**COMMONWEALTH OF KENTUCKY
BEFORE THE PUBLIC SERVICE COMMISSION**

ELECTRONIC APPLICATION OF KENTUCKY)	
UTILITIES COMPANY AND LOUISVILLE GAS)	CASE NO.
AND ELECTRIC COMPANY FOR)	2025-00045
CERTIFICATES OF PUBLIC CONVENIENCE)	
AND NECESSITY AND SITE COMPATIBILITY)	
CERTIFICATES)	
)	
)	
)

TESTIMONY OF ANDY EIDEN

June 16, 2025

Figure 6. Comparison of Residential and Business Sector's Contributions to Technical and Achievable EE Savings Potential by 2043

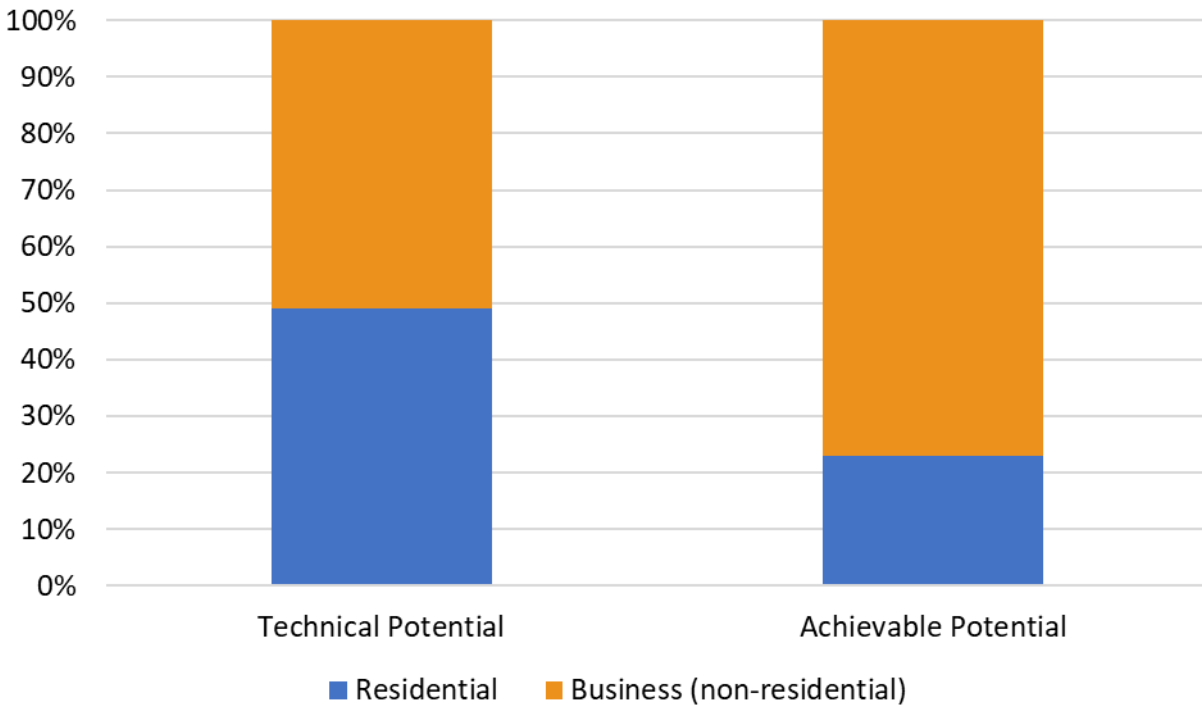
12 2030 DSM-EE Plan includes far less residential efficiency compared to the technical
13 potential for this sector. Figure 6 illustrates this dramatic change.

Looking at the sector composition of the savings from the 2024-2030 DSM-EE Plan over time, we see an even more dramatic trend in the savings makeup, where the steep drop off in commercial sector savings is not compensated for by sufficient increases in the residential sector.

1 *Figure 11: History and Forecast of Distributed Generation*¹⁴⁹

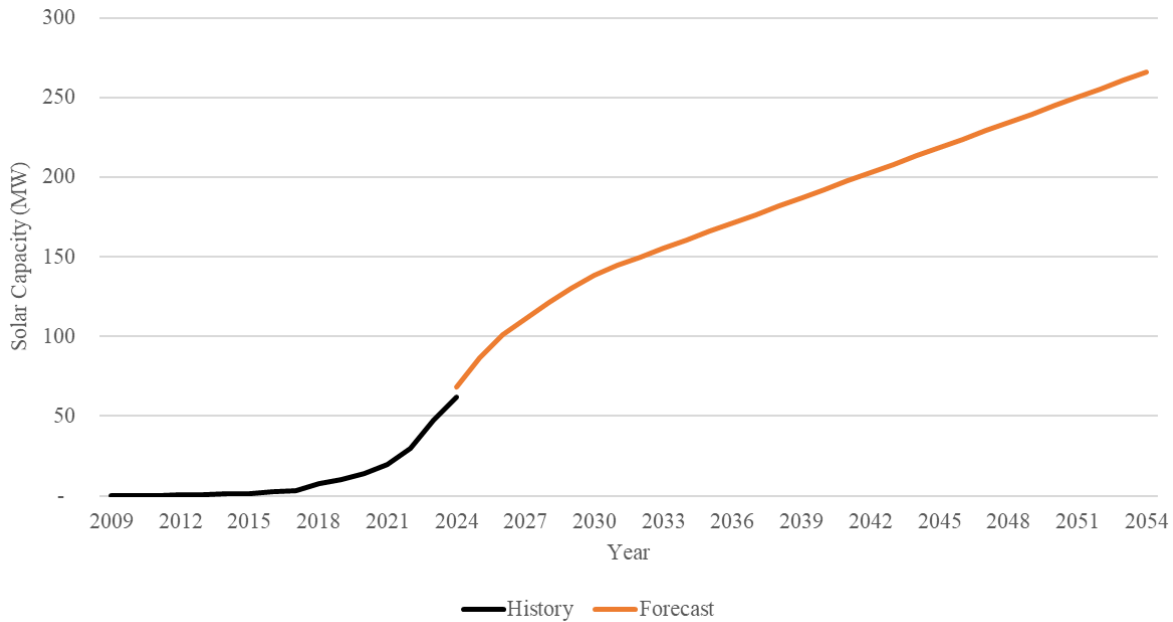
A. Yes. The Companies are including continued growth, albeit at a decreasing rate, growing from 67 MW in 2024 (base year) to 150 MW of installed capacity by 2032, and reaching 266 MW by 2054.¹⁴⁸ Figure 11 shows the forecast over the planning period.

1 *Figure 12: Companies' real to nominal conversion factors used for solar modeling*

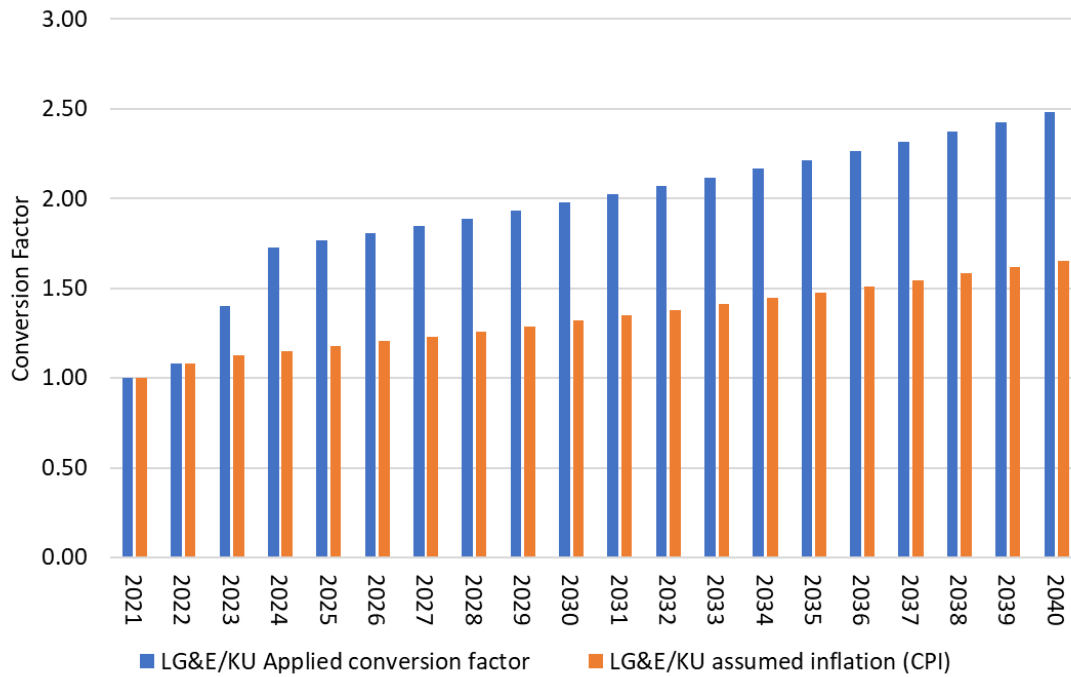
1 with a 2021 dollar year denominated in real dollars.¹⁵⁵ In order to convert the real dollars
2 into nominal,¹⁵⁶ the Companies used their own conversion factors that were dramatically
3 higher than inflation, and did not provide any documentation or justification for what
4 these conversion factors were meant to represent or where they were sourced from.
5 Confusingly, the cell column for these factors reads “Real-to-Nominal Conversion for
6 NREL ATB (Solar)”, even though nothing like this factor is found in the NREL source
7 documentation and the Companies also have a different conversion factor two rows
8 below this one called “Real-to-Nominal Conversion for NREL ATB (CPI)” that appears
9 to have values more closely aligned with expected inflation.

10 The calculations that lead to the pertinent input values, however, are based off of
11 the errant conversion factors. Figure 12 illustrates the large deviation.

1 *Figure 13: CAPEX (\$/kW) comparison utilized in avoided cost-to-LCOE metric*

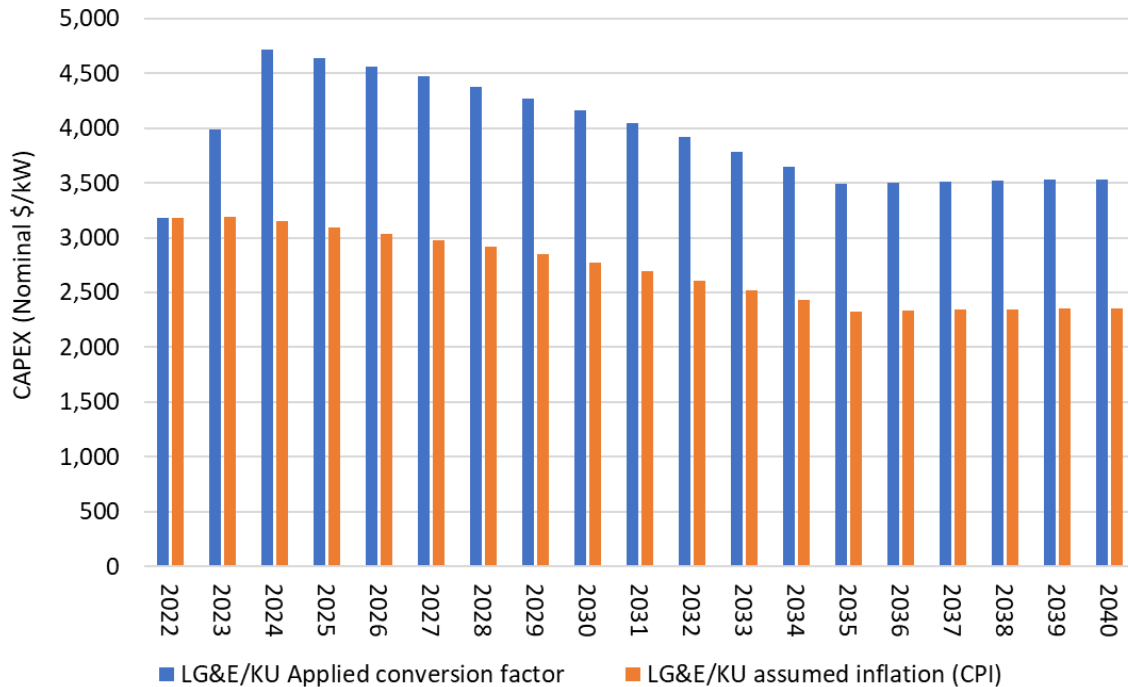
6 A. Although it is possible that the Companies intentionally applied this conversion factor,
7 Figure 13 shows the ultimate impacts on \$/kW of capex (installed cost) that results from
8 using the two different value streams, illustrating that it is unjustifiable compared to
9 recent market evidence.

2
3 Based on 2023 benchmark data from NREL, installed costs for residential solar were
4 between \$2,481/kW and \$2,849/kW,¹⁵⁷ which is much more in line with the adjusted
5 values based on the CPI index in Figure 13 as opposed to the higher system costs
6 assumed by the Companies in their modeling. The Companies' modeling of capital costs
7 leads to an additional \$13,155 for the average residential system size of 8.5 kW installed
8 in 2025.
